Document: 159-048-00 Revision: 3 Date: 11/17/21

SERVICE BULLETIN

Subject: Airbus Common Beam Master Cylinder Leakage

Helicopters Affected: EC135 / EC145 aircraft with Common Beam Cargo Hook

Figure 1 - Master Cylinder fluid leakage location

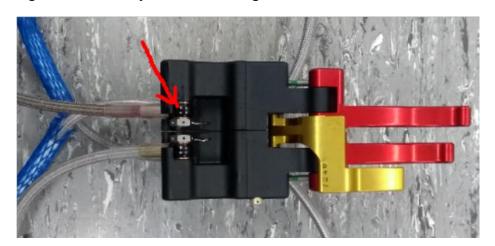
Description of Incident: Onboard Systems has been notified by Airbus Helicopters of multiple instances of hydraulic fluid leakage from 'Common Beam' Master Cylinder assemblies at the connection point between the hydraulic hose and Master Cylinder reservoir. Evidence of hydraulic fluid can be seen as wetness on the Banjo Bolt and pink-colored discoloration under the hydraulic hose protective sleeving.

Figure 2 - Missing thread relief

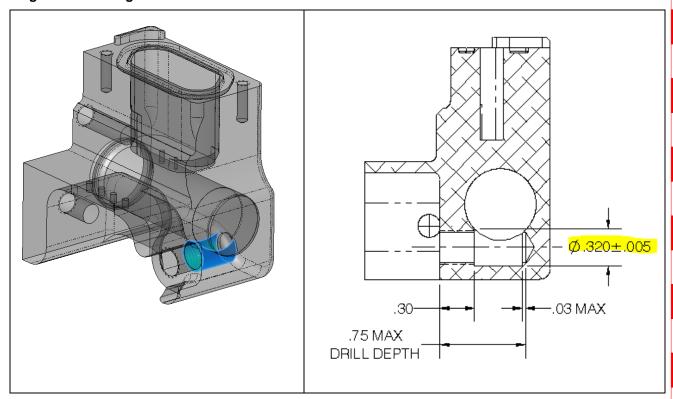
Findings indicate the primary root cause of the leakage to be a production nonconformance within both Master Cylinders (P/Ns 291-836-00 and 291-837-00). Inventory inspected showed that a thread relief was missing from physical parts: Ø.320 feature highlighted in Figure 2.

This missing feature can cause unintended interference between the Banjo Bolt (P/N 291-665-00) and Master Cylinder—preventing full clamping force of the sealing joint, even after full assembly torque. The cause of this is that the Banjo Bolt potentially bottoms out against a blind thread of limited depth. See Figures 2 & 3.

Onboard Systems will fully disassemble the Master Cylinder, add the missing thread relief depicted in Figure 2, reassemble (increasing the assembly torque of the Banjo Bolt) and re-ATP. As CNC machining is required, this process is not feasible to conduct in the field.

Figure 4 – Disassemble Master Cylinder (P/N 232-626-11 shown)

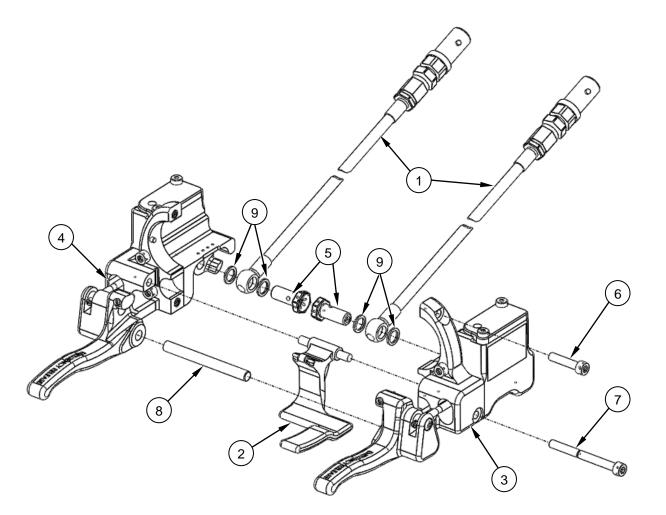
In a FOD-controlled environment, carefully disassemble the Master Cylinder Assembly to the level shown in the illustrated parts of Figure 4. Depending on the model, reference also Onboard Systems Owner's Manuals 120-217-00 or 120-220-00 for supporting information.

Figure 5 – Banjo Bolt modification

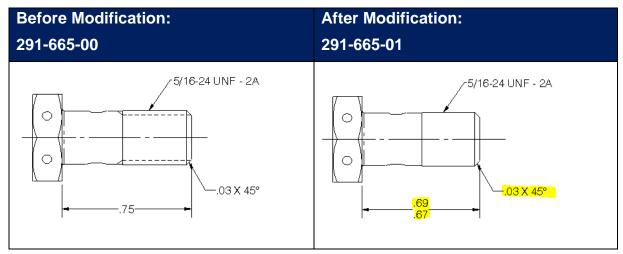
The repair procedure below outlines a modification of the Banjo Bolt. After the modification, the Banjo Bolt part number is identified as 291-665-01.

- By manual machining or grinding, modify the Banjo Bolt(s) P/N 291-665-00.
 Remove .06 .08 inches [1.5 2.0mm] of bolt length as depicted in Figure 5 below to achieve the new length of .69/.67 inches [17.5/17.0mm].
- Break the external thread sharp edge with a .03 inch [.7mm] x 45° chamfer. See Figure 5.
- Restore any deformed / collapsed threads with a small triangle file, remove any remaining burrs and thoroughly clean / degrease the part.

Ensure that the modified Banjo Bolt threads are free-running after modification & before assembly. Restore any deformed threads. Test the threads using a 5/16-24 plain nut or class -2A thread ring gage.
